Service Campaign Bulletin

Campaign No. 2021050013, August 2021

Replace Emission Control Information Label

Model 213, 238, 257

Figure 1

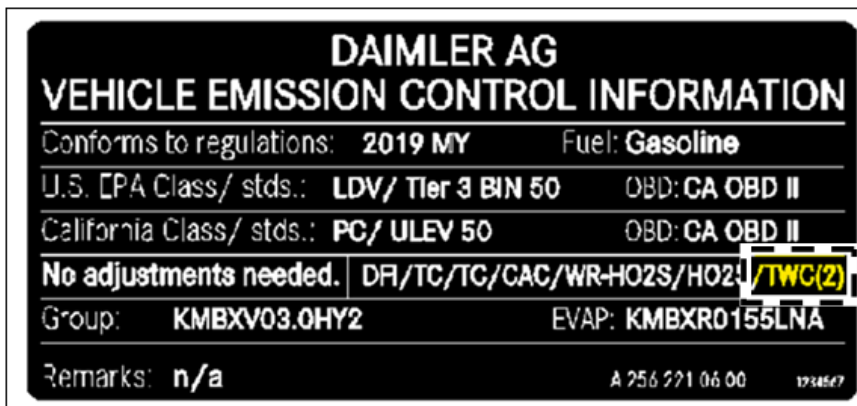
1. Open hood.
2. Replace the Emission Control Information label (**Figure 1**) on hood.
 - i** The new label must contain the text "**TWC(2)**" (**Figure 1**)!
 - i** For model 213 - bonding position 3.3, (**Figure 2**).
 - i** For model 238 - bonding position 3.3, (**Figure 3**).
 - i** For model 257 - bonding position 3.1, (**Figure 4**).
 - i** Remove old label by using a heat gun.
 - i** Contamination and adhesive residues from the old label must be removed via a thorough cleaning.
